Sportsman Service Bulletin 66A - Corrective Action

Subject: VHF COM Interference Check with Garmin 430W / 530W series GPS / COM units

Applicability: IFR equipped “Two Weeks to Taxi” Sportsmans with Garmin 430W or 530W series GPS/COM installations

Model: TWTT Sportsman with Garmin 430W / 530W GPS/ COM Units	Document: Service Bulletin 66 Corrective Action	Revision: -	Date: 2/11/08	Page: 1
---	--	---	----------------	------------------	------------

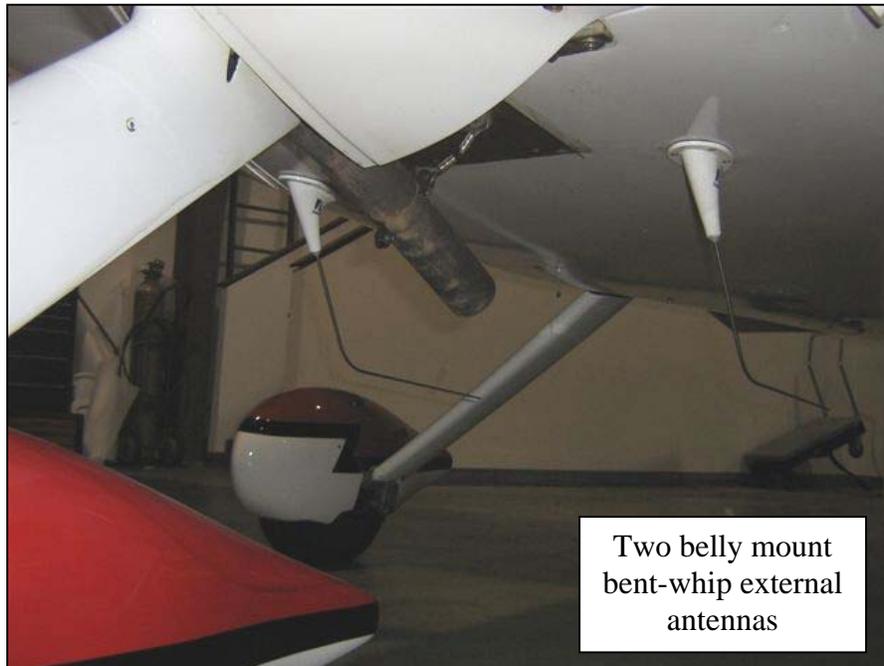
Should you choose not to install a 406 MHz ELT, our testing revealed that the 121.5 MHz ELT can be retained if the existing internal dipole antennas are disconnected and external whip antennas are installed on either the upper wing skin, or the forward belly section of the fuselage.

If you choose to install new external antennas, we recommend using the R.A. Miller AV530 stainless steel whip antenna above the wings or the angled AV17 stainless steel whip antenna on the belly.

Note: In the second half of 2007 on TWTT Aircraft, we moved the ELT forward to a location just behind Bulkhead A on the left side of the fuselage in an attempt to gain more separation from the dipole COM antenna. If this is your case, there will not be enough separation between the 121.5 ELT and forward, belly mounted whip antennas. The easiest remedy for this configuration is to switch to the 406 MHz ELT.

If your choice is to install external whip antennas, please note that we installed two AV17 bent-whip antennas on the belly of our Factory Demonstrator with good success as long as we had a minimum of a 10-foot separation between the ELT and the antennas. The reasoning behind our choice for the belly location is they are less noticeable and use far less co-ax cable; therefore simplifying the installation.
